APPENDIX D.7.6
2016 WSCC INSPECTION REPORTS
AND BAFFINLAND RESPONSES

REPORT OF AN INSPECTOR OF MINES

Mine:	Mary River project	Location:	~950 km NW of Iqaluit	
Operator:	Baffinland Iron Mines Corp.	Lat.	71-19'N	Long. 79-24'W
Manager:	Bernard Laflamme	Inspection Date:	20160114 to 19	
Address	2275 Upper Middle Road East - Suite 300 Oakville ON L6H 0C3

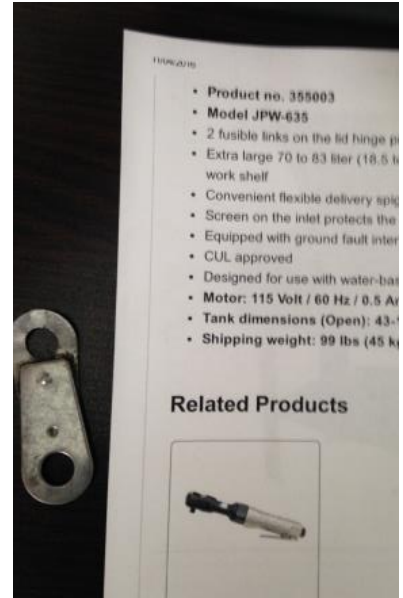
- 15. Noticed the landing at the south end of the mobile maintenance shop in Mary River, is about 12 inches above the shop floor and it is a potential trip hazard.

Please install a wide step for access to/from the shop floor to the landing

Response: *Completed: February 8, 2016*

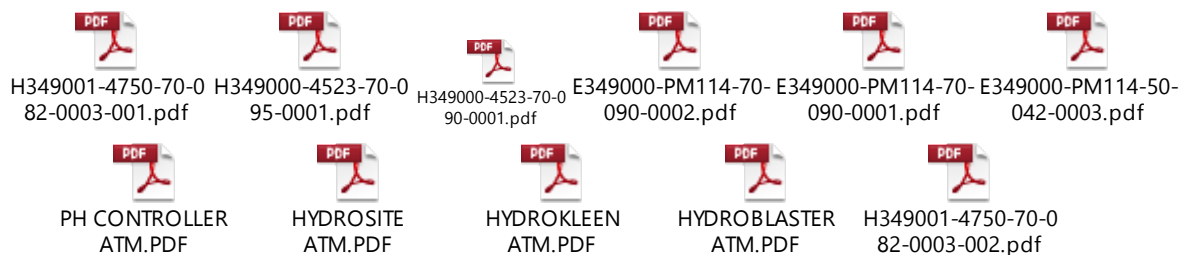
17. Noticed the truck wash shop, to wash the ore haul trucks and other mobile equipment, is under construction.

Please submit the certified electrical schematics for this shop and confirm the electrical equipment is compliant with CSA M421 Use of Electricity in Mines.

Response: Completed on February 18, 2016: See file entitled "Item 17 Verification". These files have already been sent

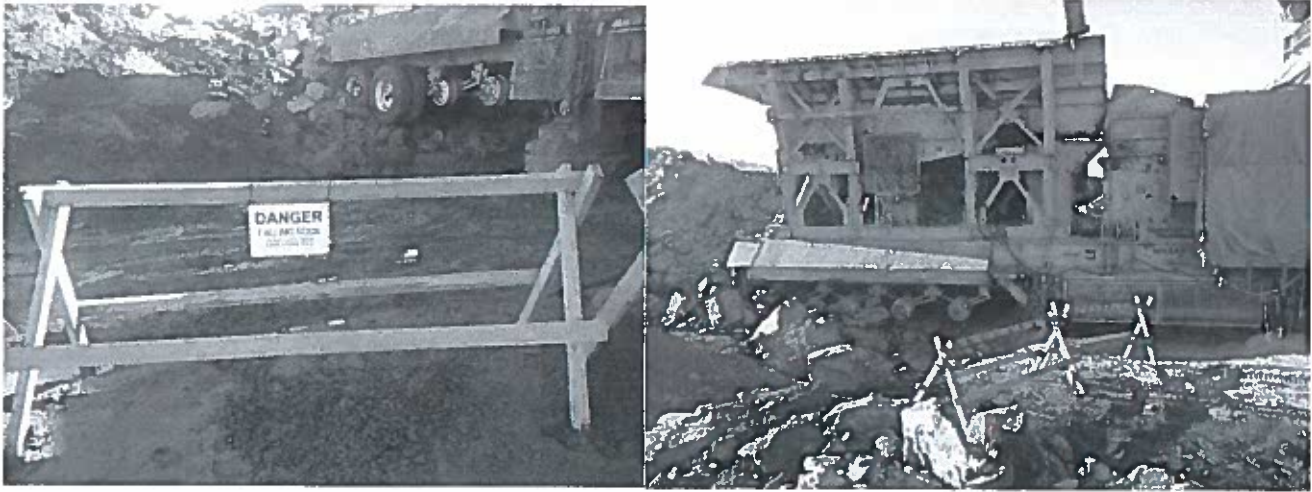
Noticed there is no barrier installed for the exposed tail pulley of the conveyor below the vibrating feeder of crusher 'A' and there are no barriers installed to prevent access by a persons to the missing belt conveyor nip-point guards at crushing and screening plant 'A', 'B' and 'C'.

15 This is a repeat infraction see inspection report 29 January 2016. Please install barricades at the crushing and screening plant 'A', 'B' and 'C' to prevent access to the moving conveyor parts or install nip-point guards.

Response: Barriers have been erected to prevent access to moving conveyor parts. Date completed June 07, 2016

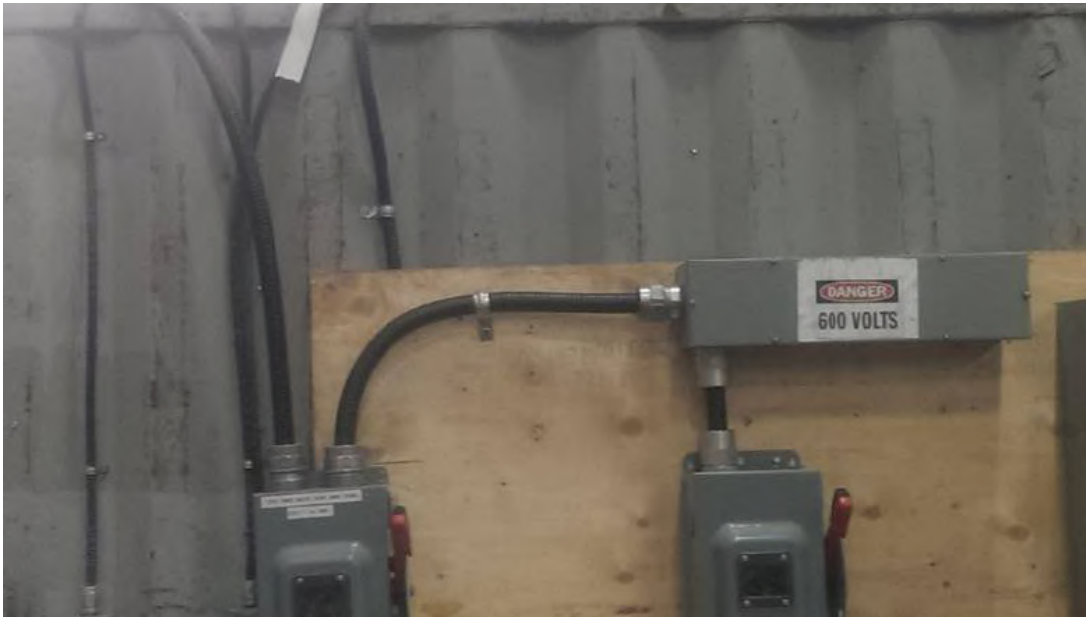
Noticed the Teck cable between the main 600V switch and the splitter at the Milne Toromont shop is bent well beyond acceptable minimum radius.

7 Please re-servise the Teck cable in accordance with the Canadian Electrical Code.

RESPONSE:

Picture above shows completion.

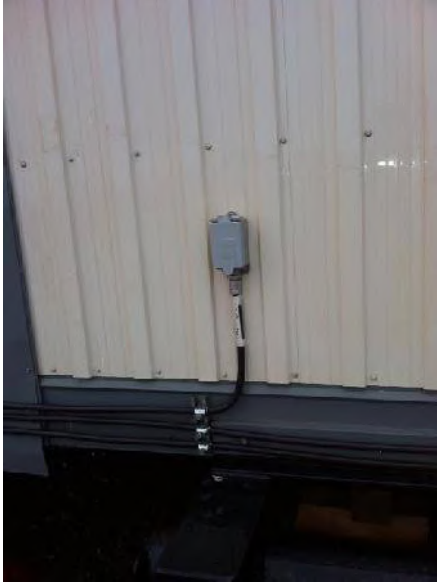
Noticed at the bit sharpening shop extension cords are used to distribute power throughout the building.

40 Please install permanent wiring in the bit sharpening shop and remove the flexible cords...

RESPONSE:
